# HISTORIC LANDMARK COMMISSION STAFF REPORT

**SK Hart Building**  
**PLNHLC2008-00693 Porte Cochere and Circular**  
**Driveway**  
**630 East South Temple**  
**February 4, 2009**

COMPREHENSIVE SITE PLAN  
A000

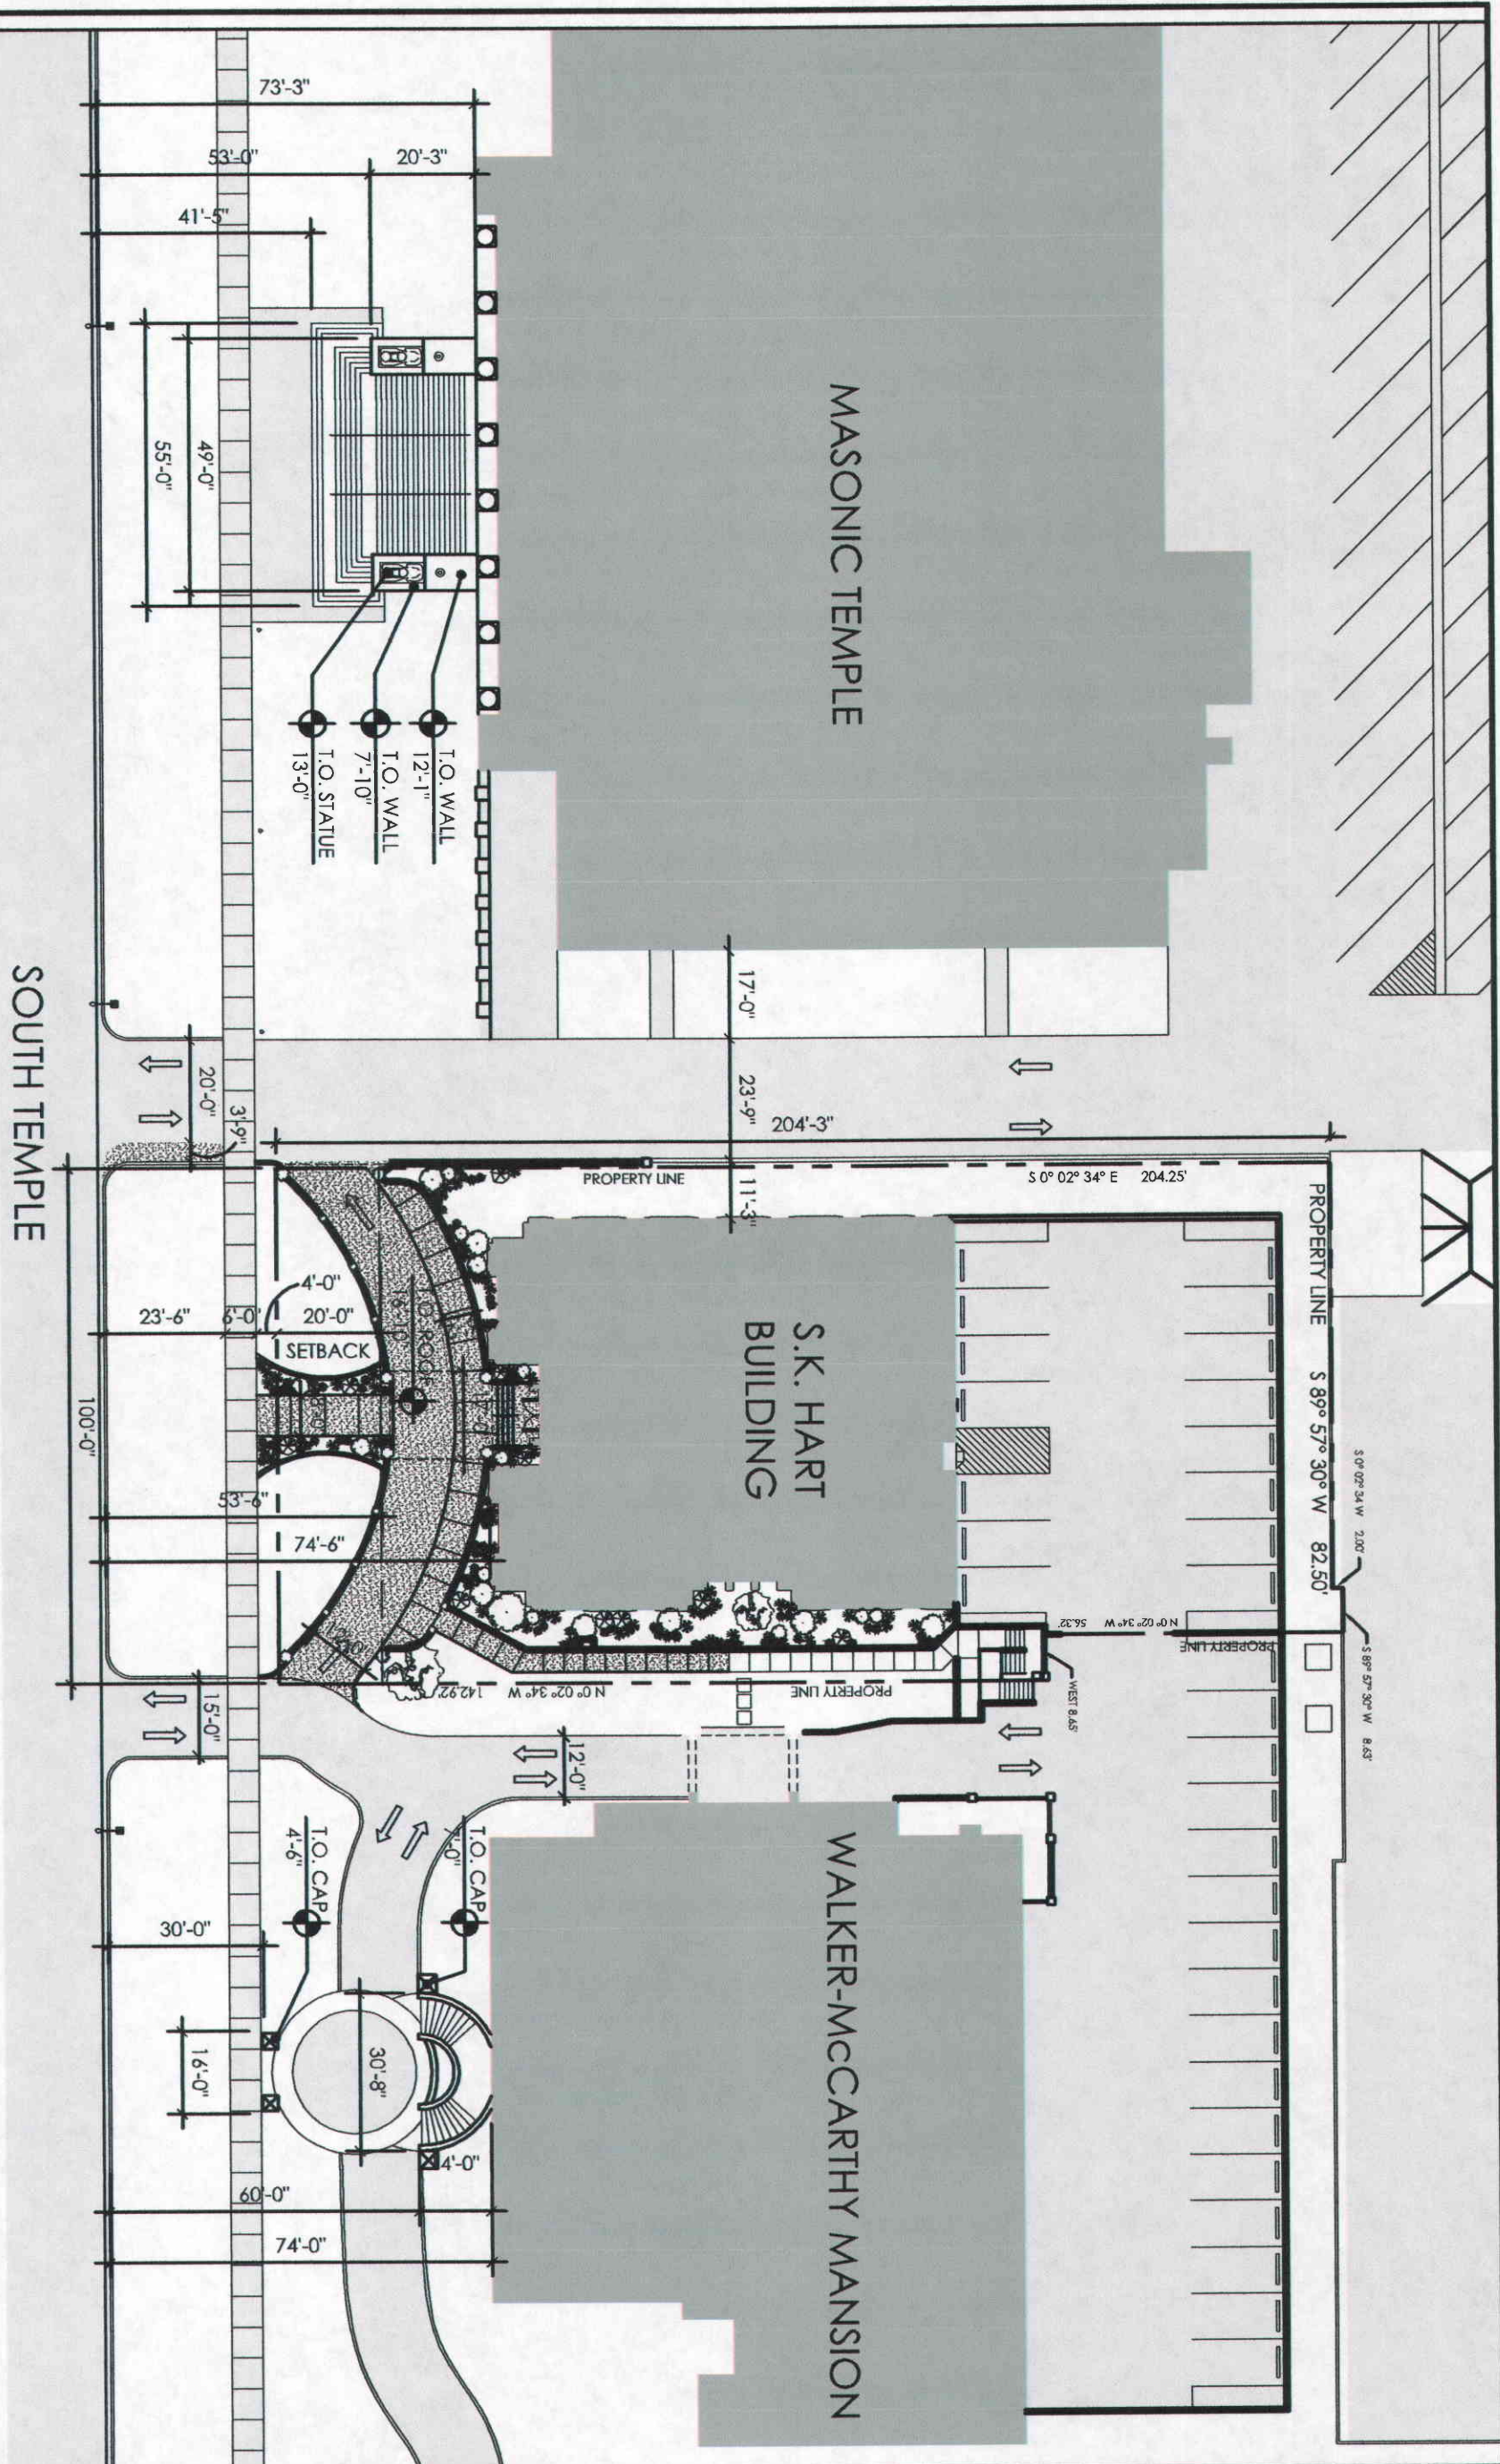
The proposed drive is in keeping with circular drive development requirements for minimum of 15' setback and 12' width.

Final geometric review approval is subject to grading information and height clearance of the Porte Cochere.

The access needs to have recorded cross easements with abutting properties at 650 East and 610 East South Temple. Past review the 1995 subdivision coordination between 630 E and 610 E for the parking structure access, may have wording or easements already recorded. Verification is required.
